MEETING NOTICE – VILLAGE BOARD (Regular)

Date/Time: Tuesday October 4th 2022 (6:00 P.M.)

A. INFORMATIONAL - New 11,890 square foot commercial building and associated site improvements (3828 Packerland Dr., HB-950-7) (Site Review Committee) (Page 16)

B. INFORMATIONAL - New 25,256 square foot commercial building and associated site improvements (4950 Founders Ter., HB-524-1) (Site Review Committee) (Page 46)

BUILDING ELEVATION - WEST
1 / A2.0 SCALE = 1/8" = 1'-0"

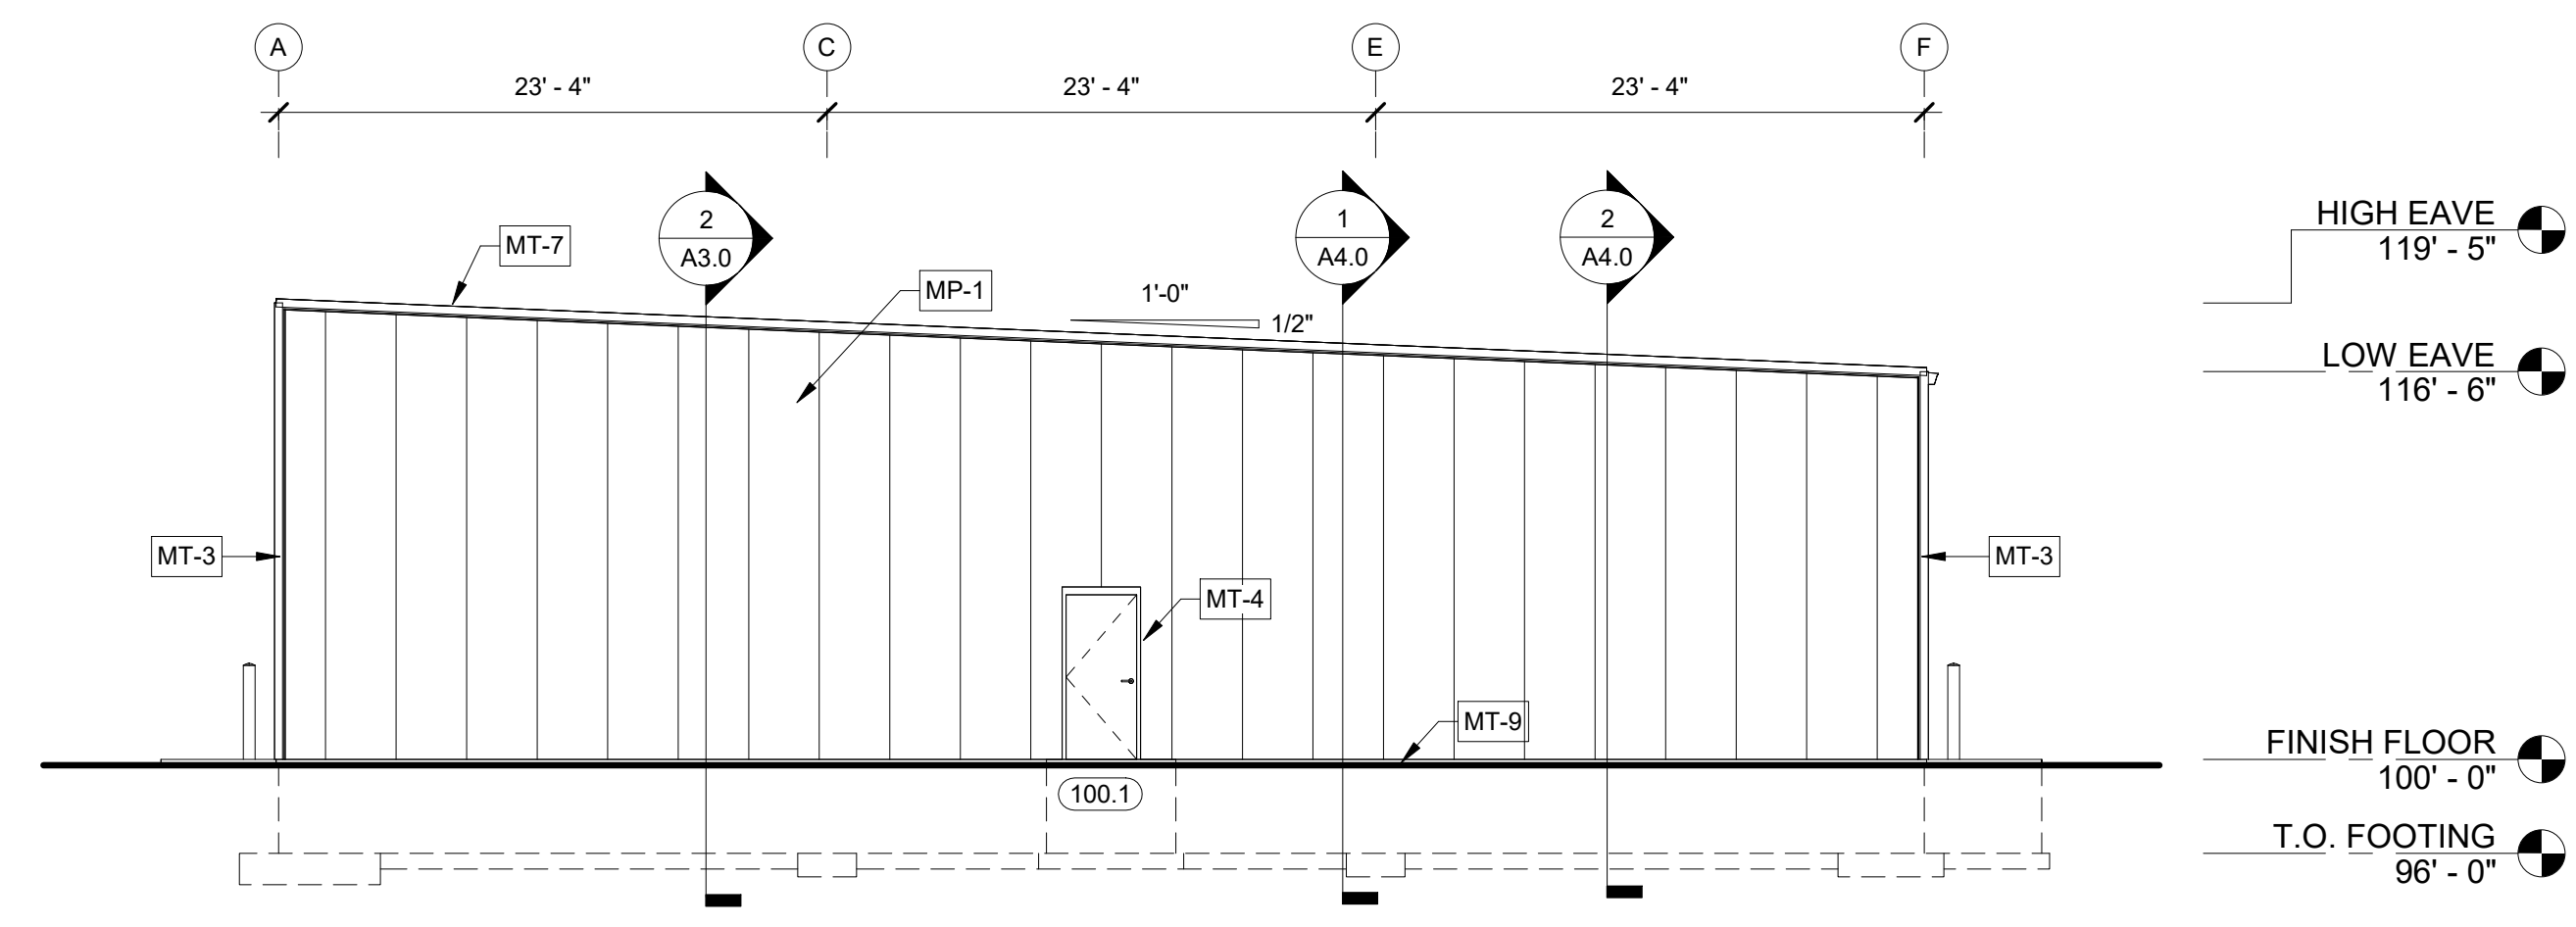
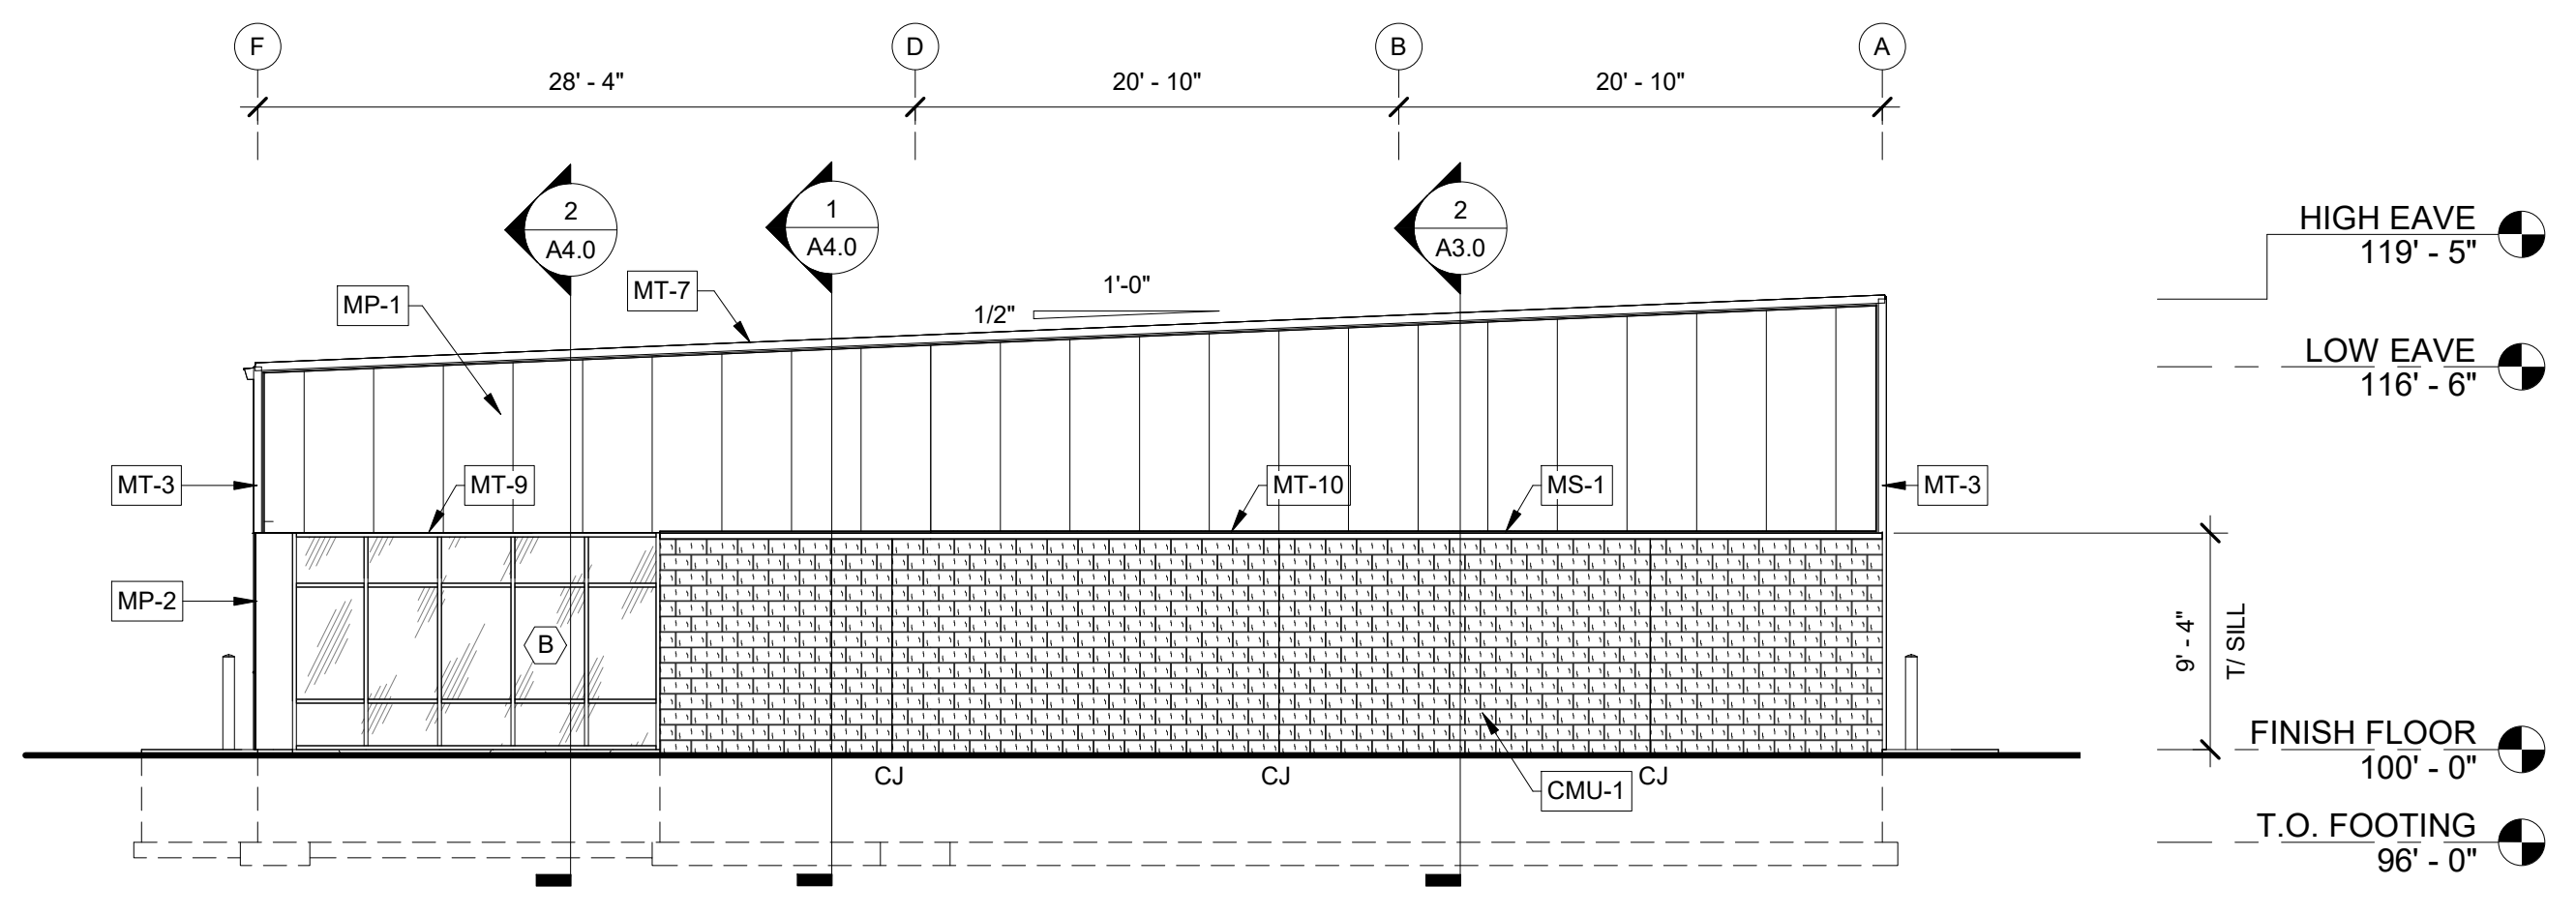
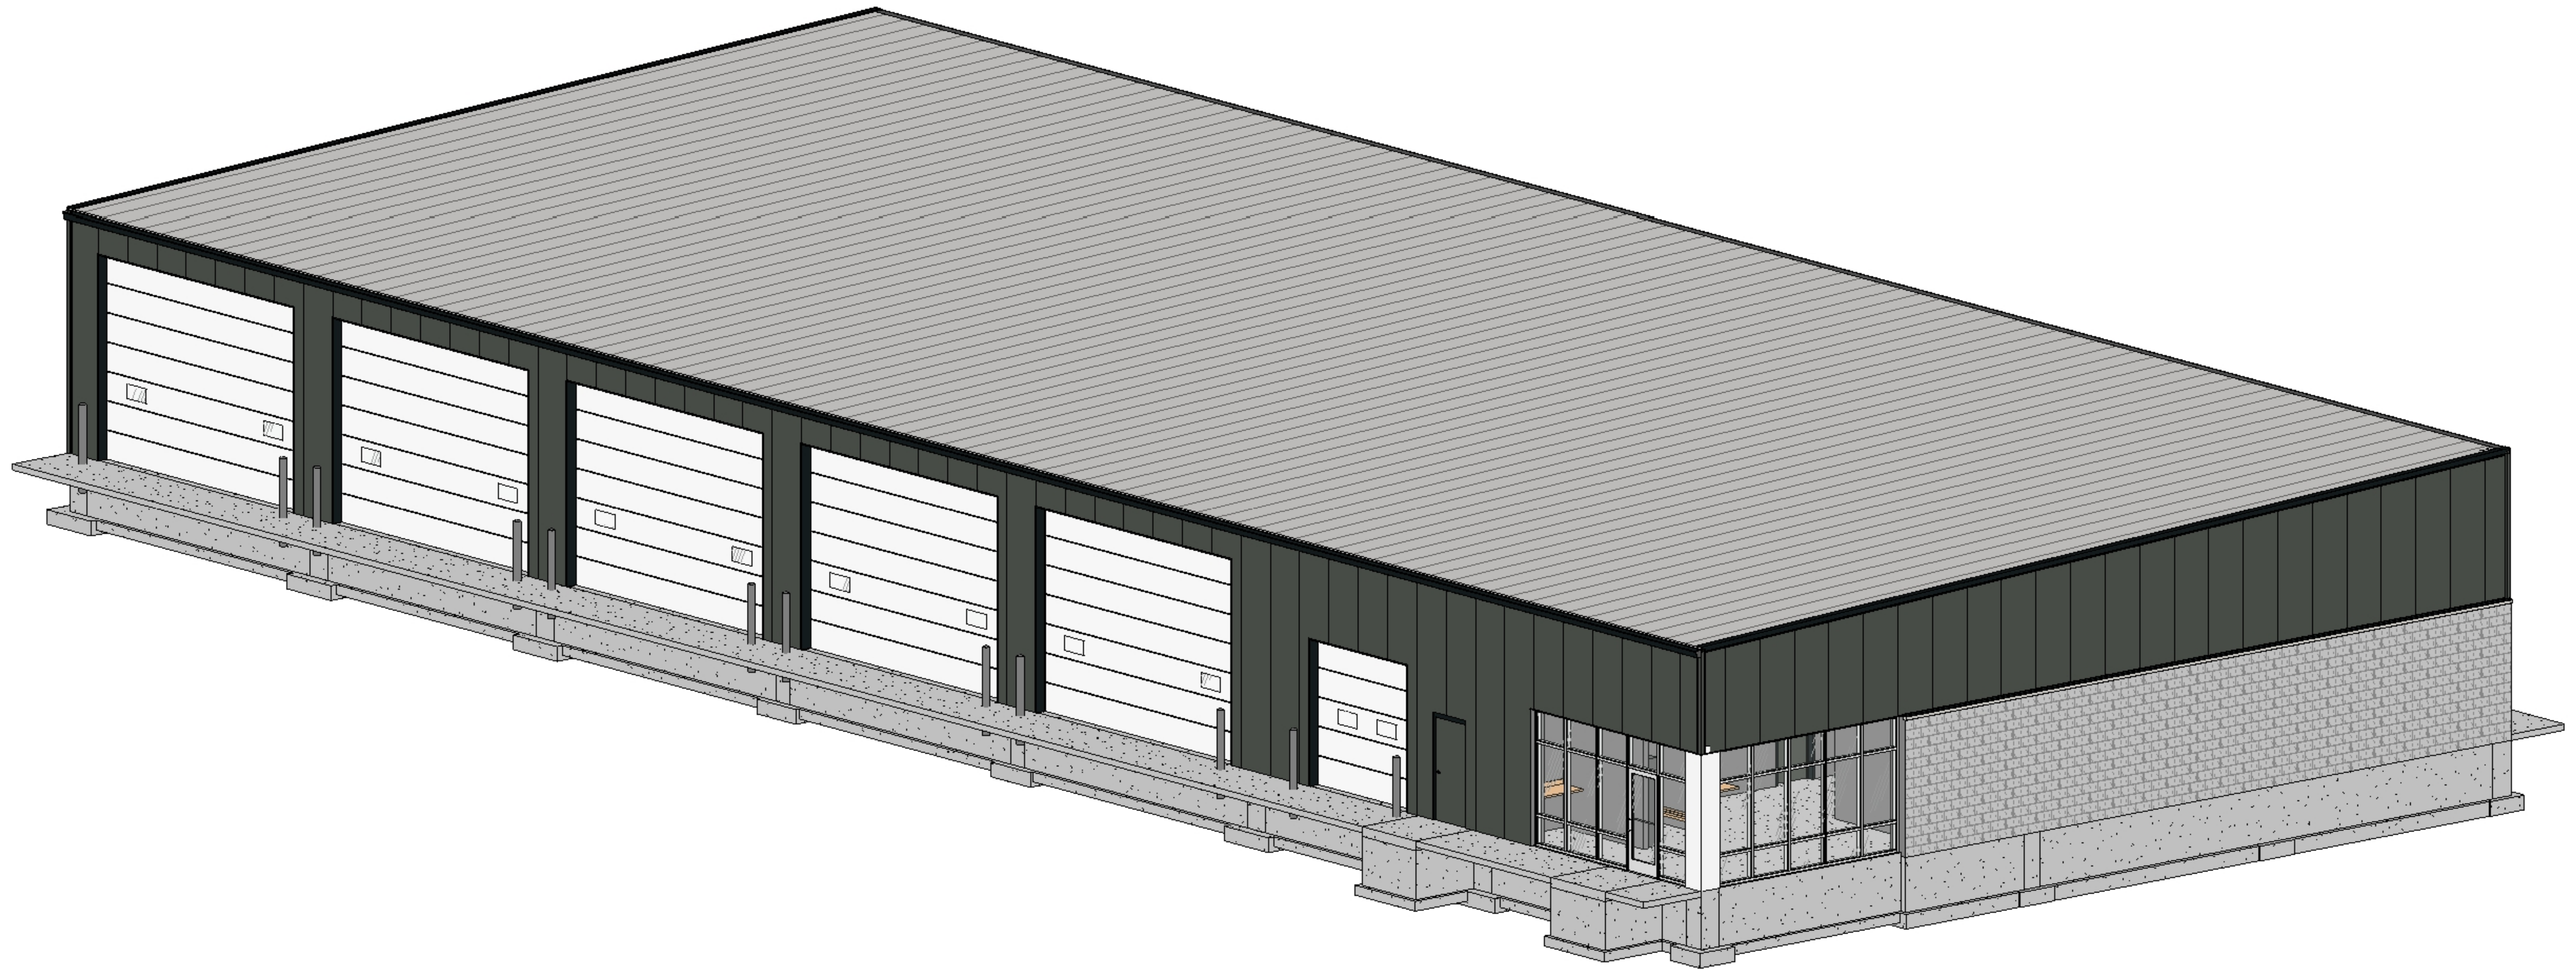
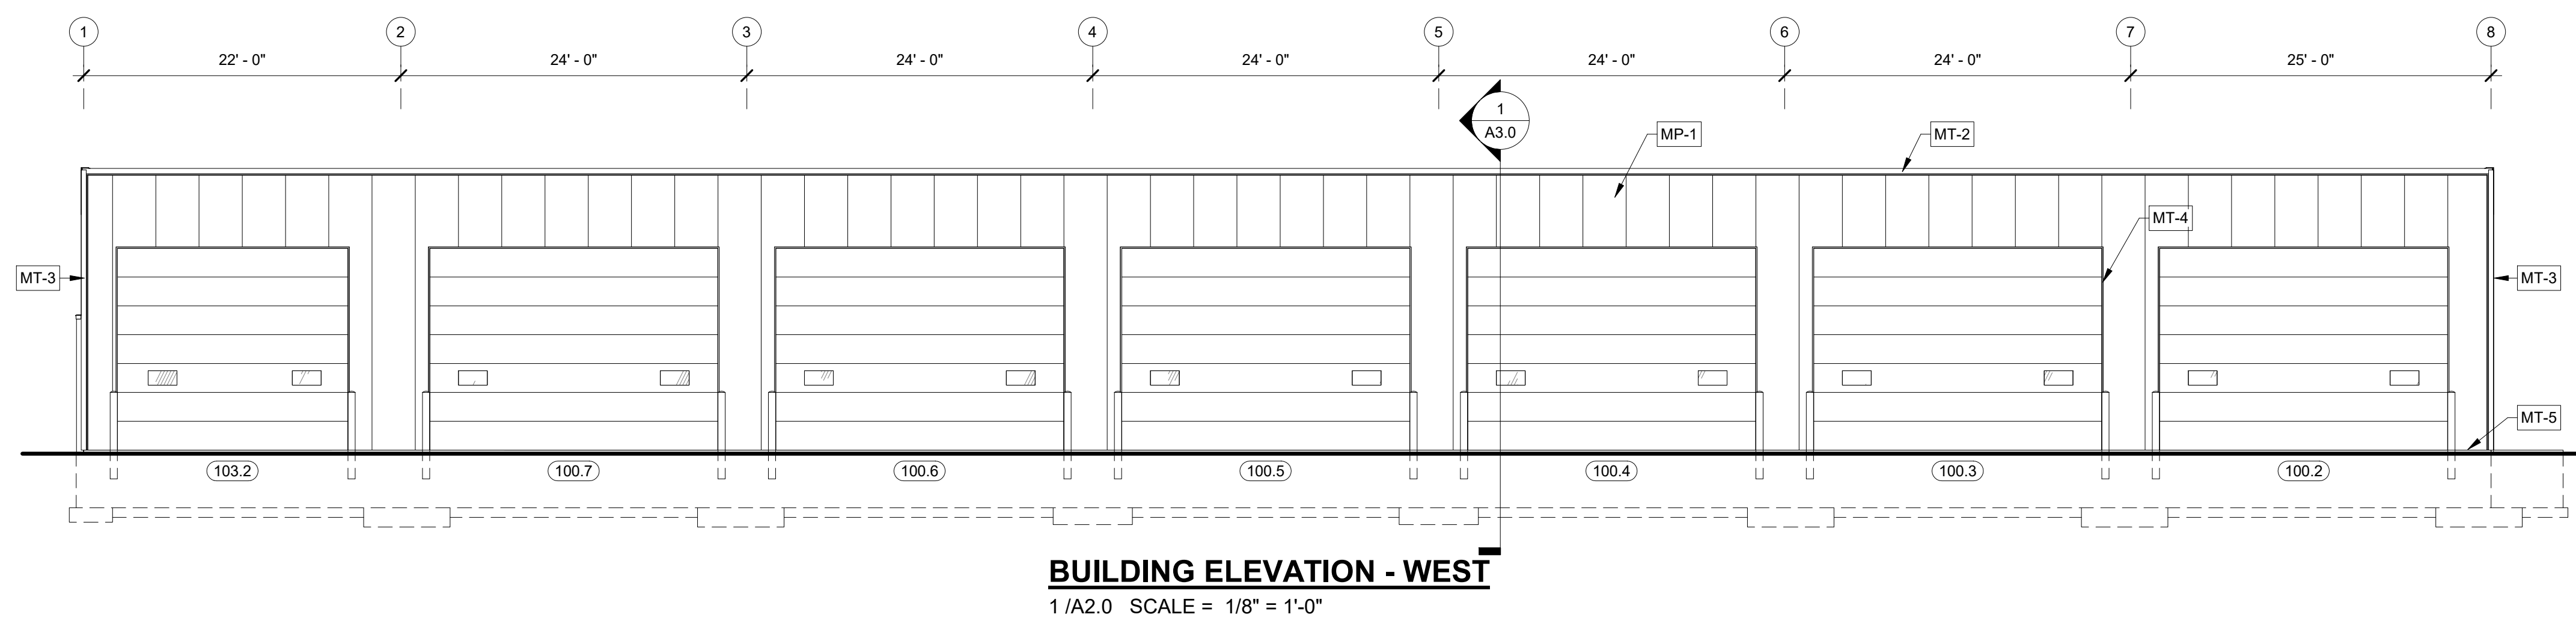
1. **Materials:** Metal frame building
2. **Exterior Materials:** Front wall of building facing Packerland Dr. will have a combination of split face CMU veneer and semi-concealed fastener metal wall panel wall panels. As for the percentage of masonry along the front elevation, the plan meets the minimum 35% masonry along the front elevation of the building.
3. **Height:** Overall height of 19'-5"
4. **Overhead doors:** All overhead doors on located on the north and south building elevations which are both side walls of the proposed building.
5. **Mechanical equipment:** There is no mechanical equipment shown, however, any roof mounted equipment shall be screened from view by materials compatible with the primary building.
